**Request for Additional Information
Revalidation Review
Docket No. 71-3090 – CAC N° L25036
Model No. LEUPA**

LEUPA

Type B(U) Package for Contain Fissile Substances

The following document contains answers to the "RESUBMITTAL OF REQUEST FOR ADDITIONAL INFORMATION FOR THE MODEL NO. LEUPA PACKAGE".

Picture 27: Primary containment flange after tests

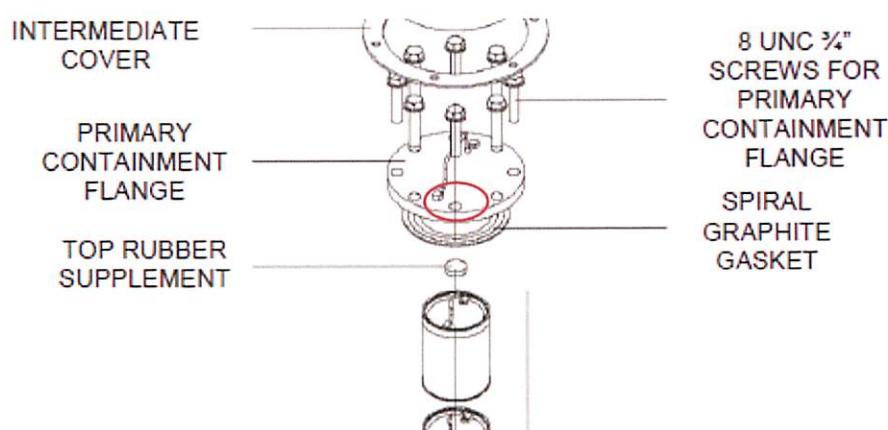
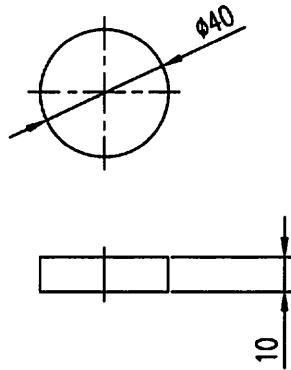
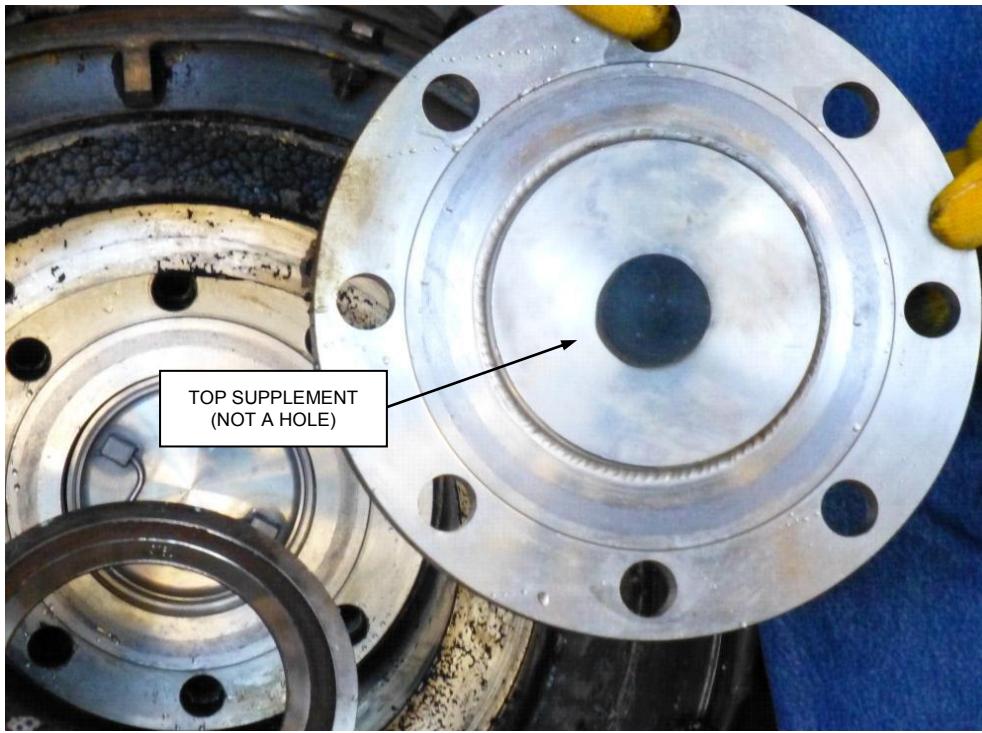
The figure of concern is Picture 27 of the "Tests Final Report" document (shown here).

The picture above (i.e., figure) does not appear to be of or about the primary containment flange per the discussions and per the figure submitted in the RAI responses. It is not clear what this component is. Based on the figure submitted in the RAI responses, the metal object shown in the foreground of the picture, is not part of the packaging since that figure does not include it. It is also not clear that the

design drawings include this metal object either. If this metal object in Picture 27 is the primary containment flange, then the submitted figure and the

English version of the figure that is on page 27 of 30 of the Safety Report (Document No. 002 0908-LE00-3BEIN-023-A) (see cut out of figure from Safety Report page 27 of 30 below) and the design drawings (see a cut out of Drawing No. 00B 0908-LE01-3AEIN-005-A below) are not correct and must be fixed because these show the primary containment flange as a solid lid with a handle and a cadmium component (whereas this Picture 27 has a large hole in the middle of the flange). The object with a handle in Picture 27 appears to be the top most of the four inner cans that are loaded into the package.

Figure 27 of the document "Test Final Report" show the bottom view of the blind flange of the container of inner cans. The flange has on its bottom face a rubber supplement, as shown in the figure below:

The following figure is from Drawing No. 0908-LE01-3AEIN-020, and shows the supplement dimensions:

The following figure is from the Drawing No. 0908-LE01-3AEIN-005, and shows a sectional view of the blind flange, where you can see a rectangle of 30 mm on the bottom face, but this corresponds to a plug for casting cadmium which closed after the Cadmium is casted.

In Figure 27 from the "Test Final Report", the plug from the previous figure is covered by the top rubber supplement:

In conclusion, the blind flange does not have any hole in its center. The following image shows the same face of the flange but without the top rubber supplement.

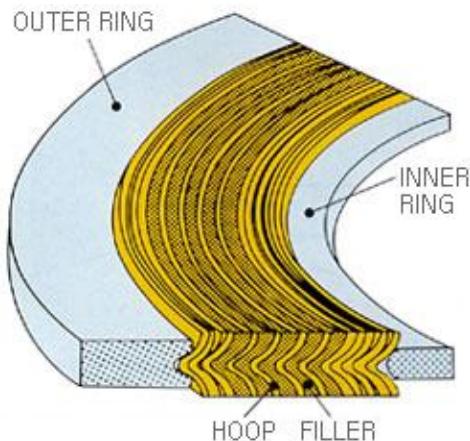
- a. The metal containment boundary AND the spiral gasket seal is designed and evaluated under a reduction of ambient pressure to 60 kilopascals(kPa), per IAEA paragraph 643.
- b. The spiral gasket and its corresponding gasket groove is designed and evaluated for an internal pressure that produces a differential pressure of not less than the maximum normal operating

pressure plus 95 kPa, per IAEA paragraph 619. The response should also explicitly state the maximum normal operating pressure.

- c. Specify whether a complete LEUPA containment boundary, including spiral gasket seal, successfully passed a hydraulic pressure test (perTable 1 of document No. 0908-LE01-3BEIN-011-A).

Note: These questions are asked because the focus of the finite element analysis in document No. 0908-LE01-3BEIN-011-A (for example, Figure 2) was on the vessel, with no mention that the spiral gasket seal could satisfy the pressure differentials.
